TECHNISCHE INFORMATION NR. SI 36-110

Rotax Service Bulletin Nr. SB-912-071 und SB-914-053

Replacement of oil filter for ROTAX® Engine Type 912 i, 912 and 914 (Series)

Fig. 1
Oil filter

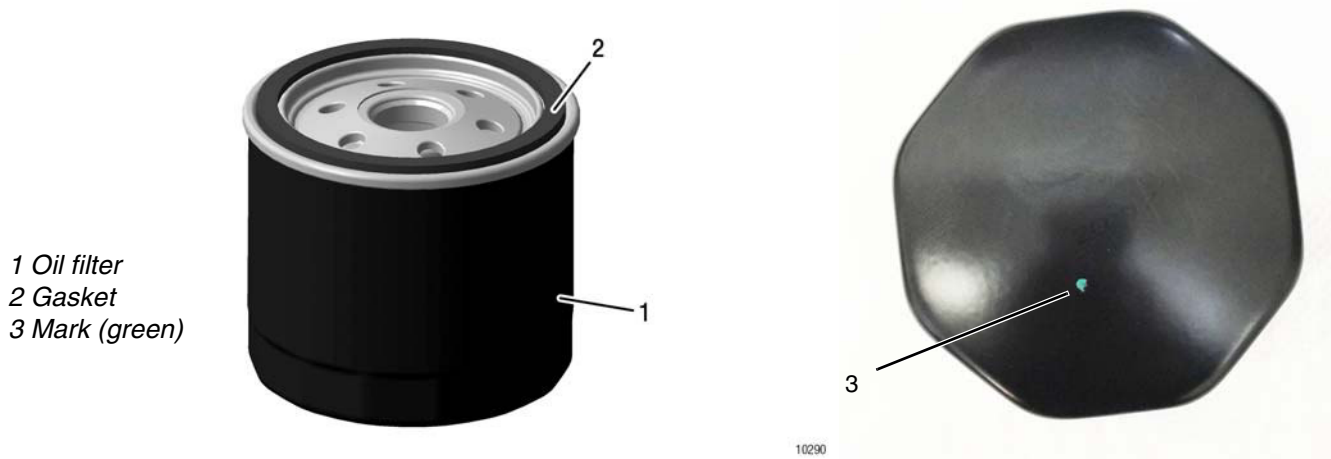
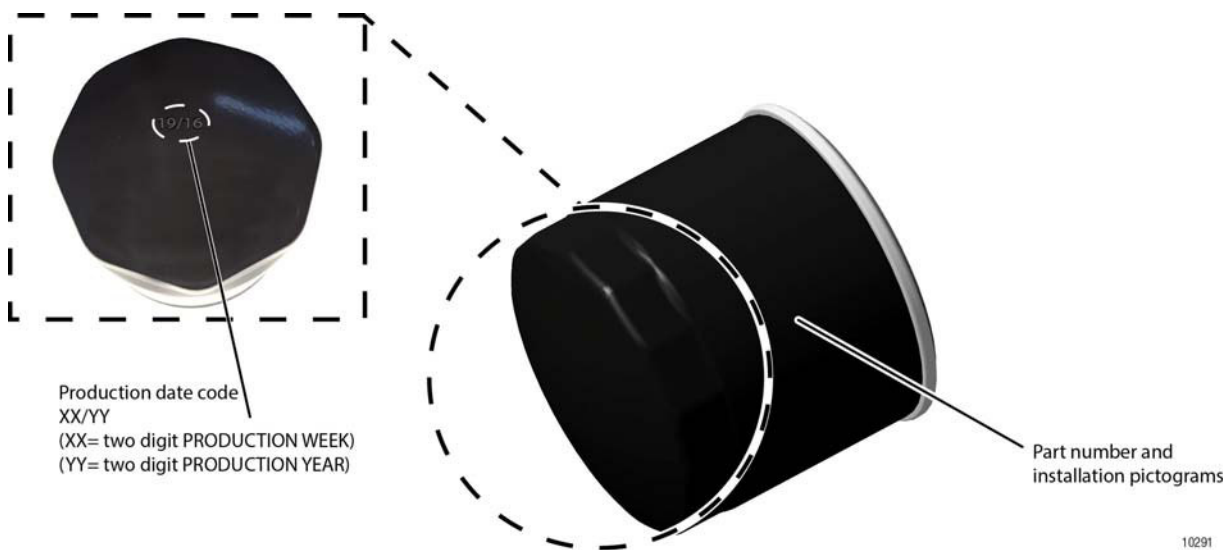
The above engines have been fitted by the manufacturer with an oil filter part no. 825016 with a production date code 10/17 up to 38/17 and have no green mark see Fig. 1).

All engines are affected, which have been equipped with an oil filter part no. 825016 (with a production date code from 10/17 up to 38/17) during engine repair, maintenance or general overhaul as of June 8th, 2017 to October 31st, 2017 and have no green mark. see Fig. 1).

Step	Procedure
1	Check the engine logbook and maintenance documentation or shipping documents to see if this Service Bulletin has already been accomplished.
2	<p>Check whether the affected oil filter shows a green mark on the crown of oil filter (as illustrated in Fig. 1) (same area as production date code).</p> <ul style="list-style-type: none"> - green mark is present: this oil filter is OK as it has already been tested by the supplier and can be used even though the production date code is from 10/17 to 38/17. No further actions are required. - green mark NOT present: this oil filter is NOT OK, please follow the instructions in section 3.2). <p>NOTE: If production date code is not easy to read, use a proper means of light (e.g. flashlight directed at a proper angle onto the oil filter crown etc.) for better visibility of the coding imprint.</p>

Step	Procedure
1	Remove the affected oil filter according to the Maintenance Manual Line.
2	Install the new oil filter according to the Maintenance Manual Line.
